PROPOSED FACILITY FOR:  
**ERIN SQUARE**  
 801 SOUTH PARK STREET  
 MADISON, WISCONSIN

## Traffic Engineering and Parking Divisions

December 22, 2011

SUBJECT: **801 S Park Street – Rezone – Construct two-story mixed-use building with a drive-thru window**

**1 SITE PLAN**  
 C-11 SCALE: 1" = 10' - 0"

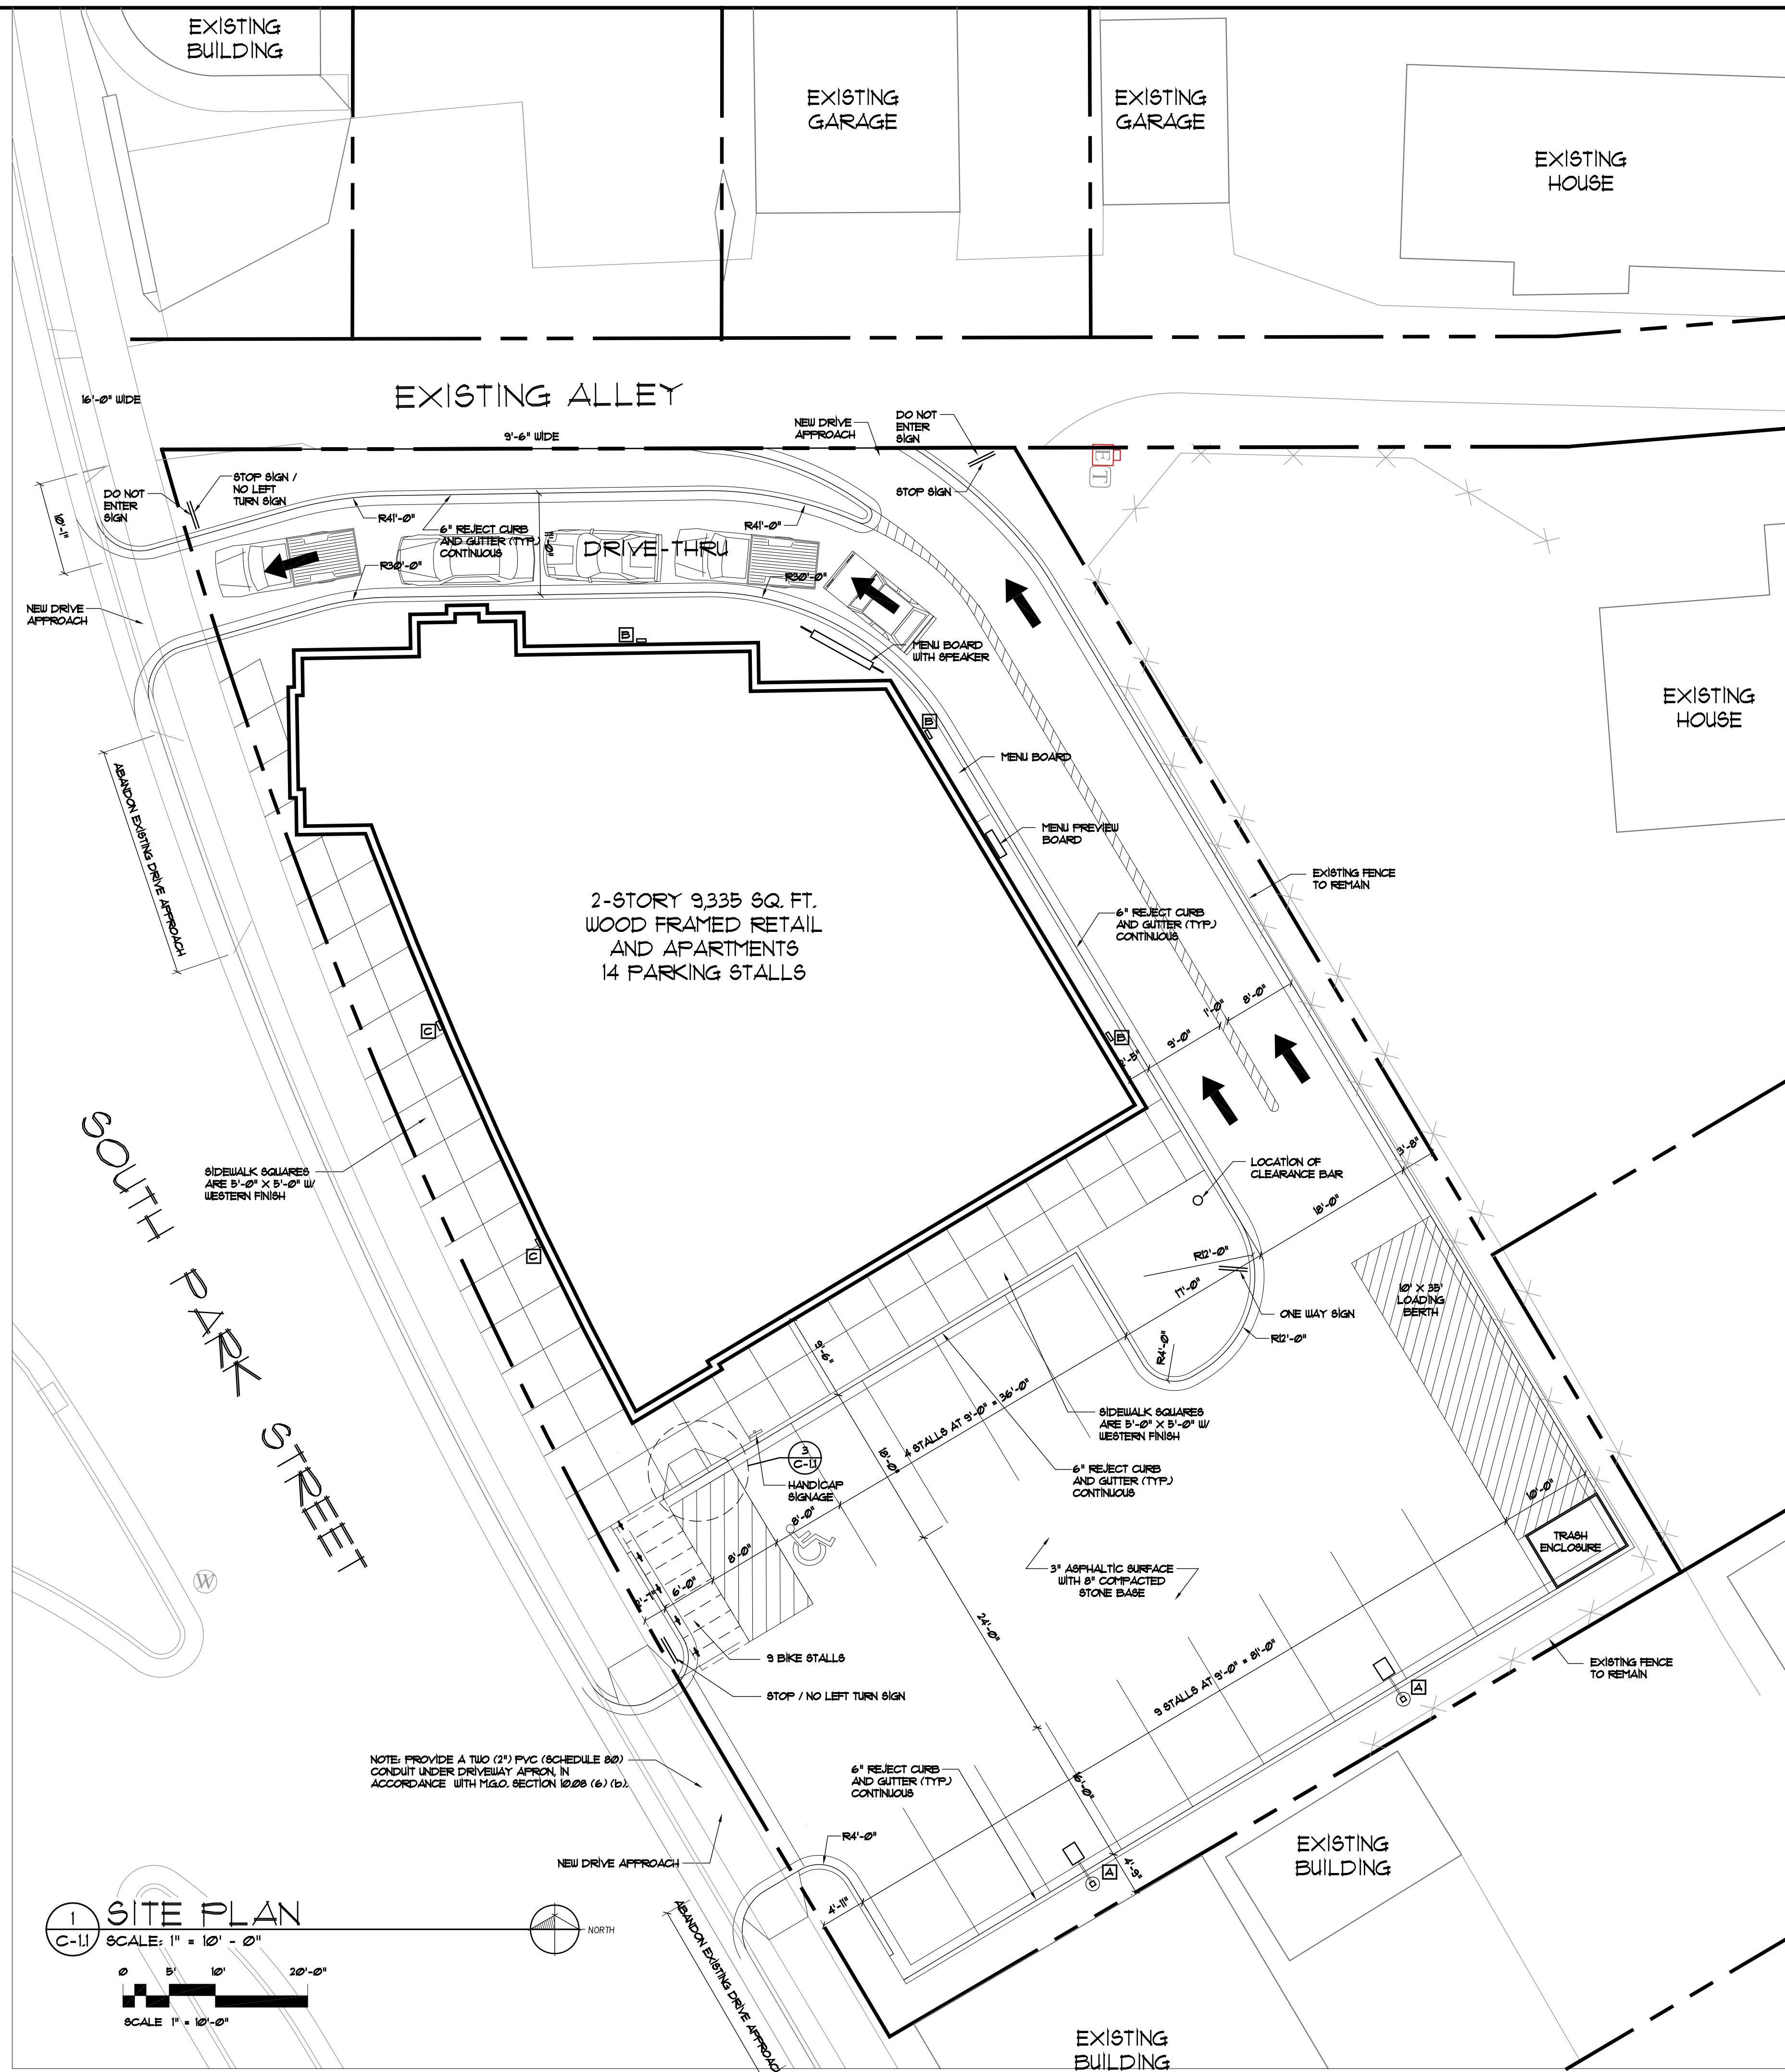
1. **The proposed drive-thru shall be modified to minimize the impact of traffic on the public alley. The plans shall be revised to using Park Street as the exit for the drive-thru and escape lane, rather than the public alley. There is also a question as to the need for the bypass and extra space provided there.**

2. **Added landscaping features may be added at the easterly property line next to the drive-thru to serve as noise reduction features for the menu board.**

5. The Applicant shall provide to Traffic Engineering for approval, a Queuing Model showing provision for vehicles for each service point queue storage that prevents queue interference with pedestrian or other vehicular movements.
6. The Developer shall post a deposit and reimburse the City for all costs associated with any modifications to Traffic Signals, Street Lighting, Signing and Pavement Marking, and conduit and handholes, including labor, engineering and materials for both temporary and permanent installations.
7. Public signing and marking related to the development may be required by the City Traffic Engineer for which the developer shall be financially responsible.
